GFA AIRWORTHINESS DIRECTIVE

- TYPE AFFECTED:** DISCUS-2T Serial No's 1 to 40
DISCUS-2cT Serial No's 1 to 30
VENTUS-2cT Serial No's 1 to 179
- SUBJECT:** Cracks in Engine Mounting Pylon.

Engine mounting structure (pylon)

**Technische Mitteilung Nr.
Technical Note No.
863 - 13 825-38**

Front view of pylon

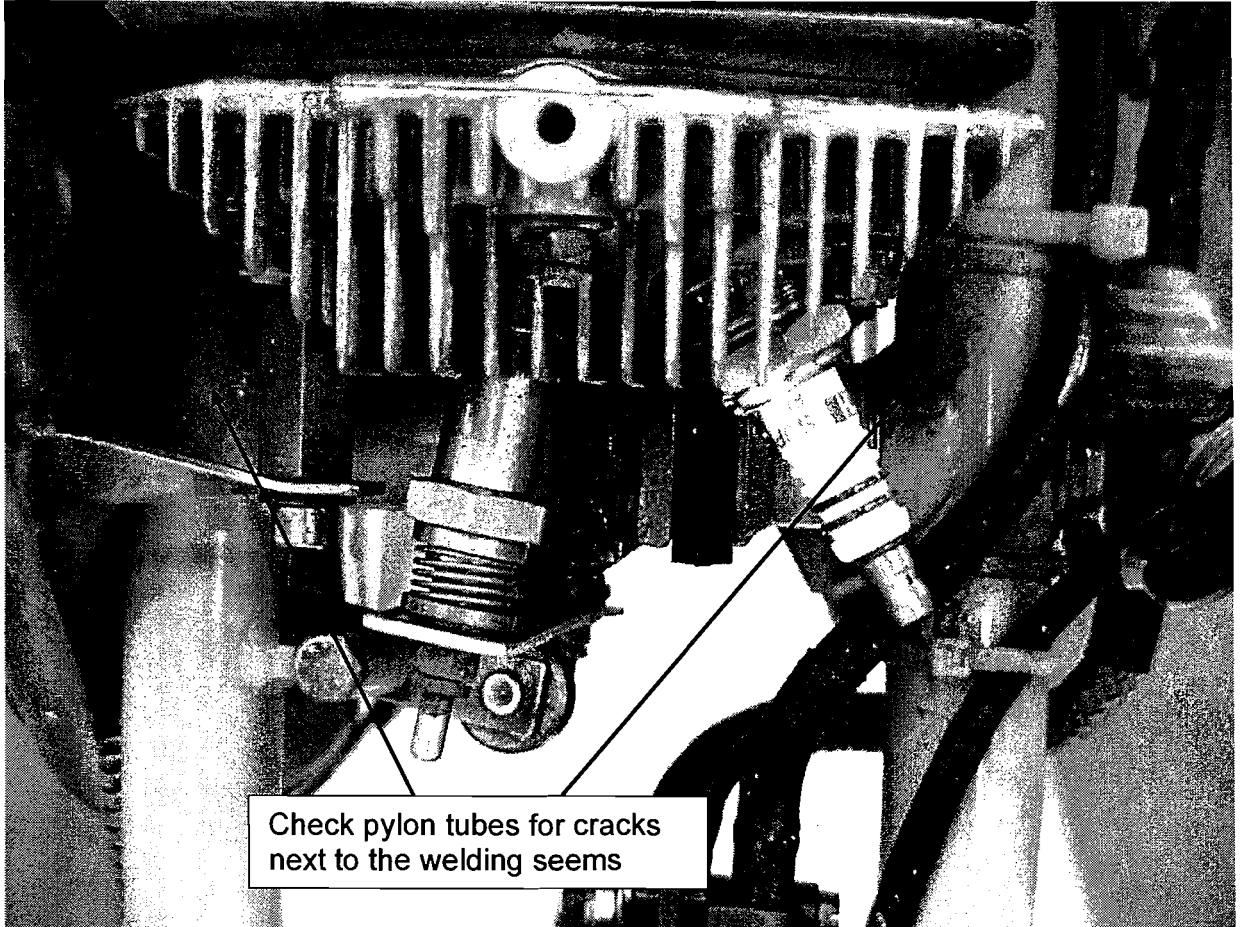
Check pylon tubes at the welding seams of the lower engine mount for cracks - see photographs enclosed to the Appendix of this Technical Note. Clean the affected areas at first if necessary.

Sketch 1: Lower engine suspension, dimension „a“ between the pylon flanges (Rubber mount loose)

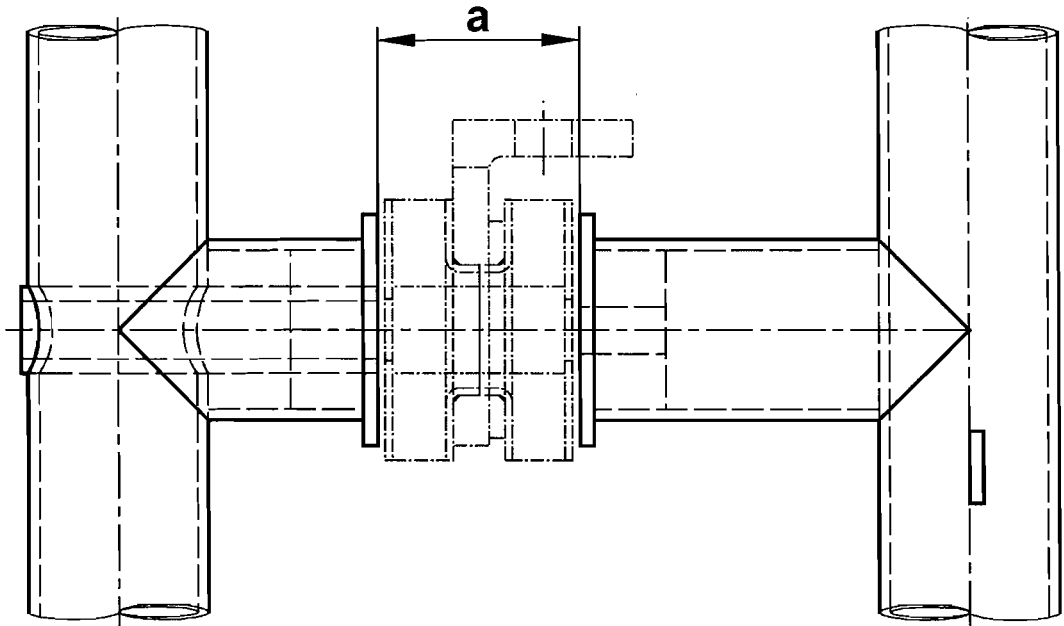
2. Determine the distance between the flanges of the pylon with a slide gauge (see sketch 1, dimension „a“). When measuring dimension „a“ the rubber mounts between the pylon flanges must be loose or may be compressed only slightly.
3. Now the gap between the pylon flanges and the rubber mounts is adjusted by fitting on both sides of the rubber mounts suitable spacers between the pylon flanges and the rubber mounts. The gap is adjusted in a way that after the lower engine suspension bolt is tightened the distance between the flanges is readjusted to the dimension „a“ from the released pylon.

The necessary spacers are selected according to the table below:

Dimension „x“ = a-26,5mm („x“ = a-1.043 in.)	Thickness of the spacers to be installed:
$2,0\text{mm} \geq x > 1,5\text{mm}$ (0.0787 in. $\geq x > 0.05906$ in.)	2 x 1,0 mm
$1.5\text{mm} \geq x > 1,0\text{mm}$ (0.05906 in. $\geq x > 0.03937$ in.)	2 x 0,75mm
$1.0\text{mm} \geq x > 0,5\text{mm}$ (0.03937 in. $\geq x > 0.01969$ in.)	1 x 1,0 mm, to be installed on the left hand side

Install the spacers with some grease. If dimension “x” should be beyond the range given in the table above please contact the manufacturer before you take any further action.

Sketch 2: Complete assembly of the lower engine suspension with spacers installed and suspension bolt tightened.

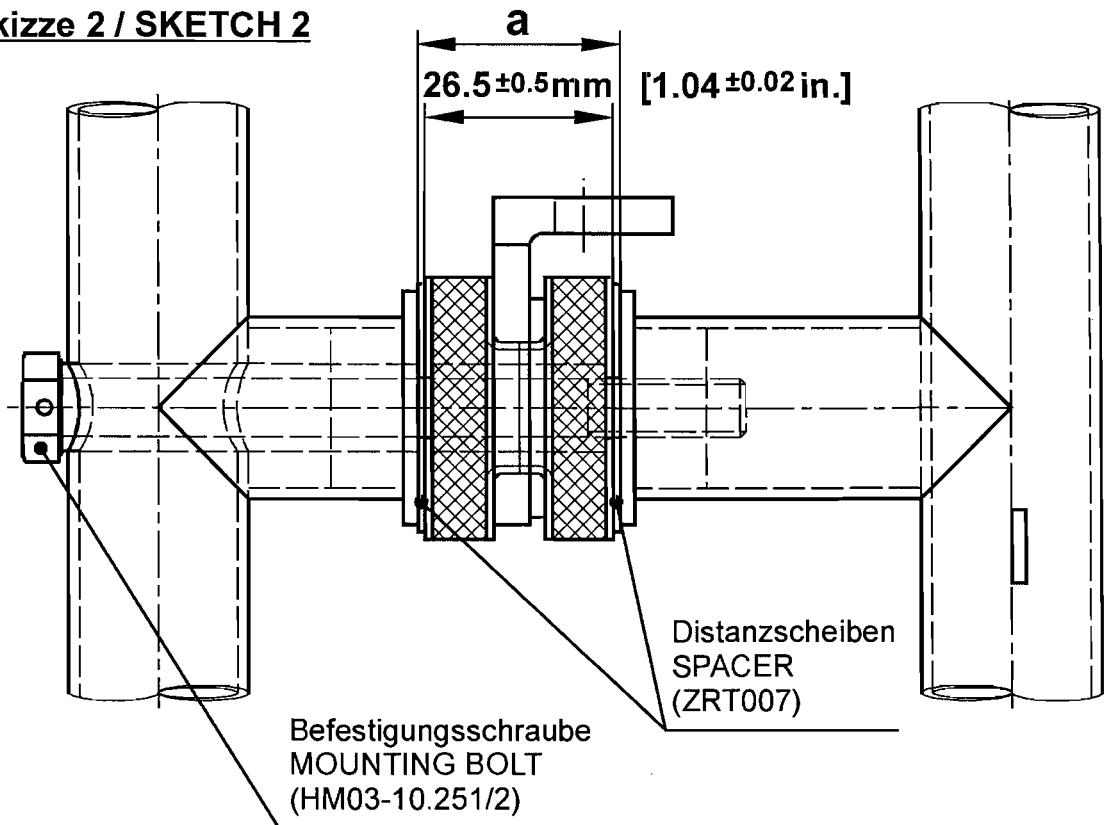
4. When the spacers have been installed insert the lower attachment bolt. Tighten the bolt so far that the rubber mount is compressed to the dimensions listed in the Flight Manual (s. sketch 2, dimension 26,5mm±0,5mm resp. 1.043in.±0.01969 in.):

Check that the engine and the exhaust have sufficient clearance to the engine mounting structure (pylon). Retract the engine and check that the engine travels into the engine bay without collision with the fuselage and that the doors close completely. In case of interference check you may also install the spacers only on one side of the rubber mounts.

5. Secure the lower attachment bolt with securing wire.
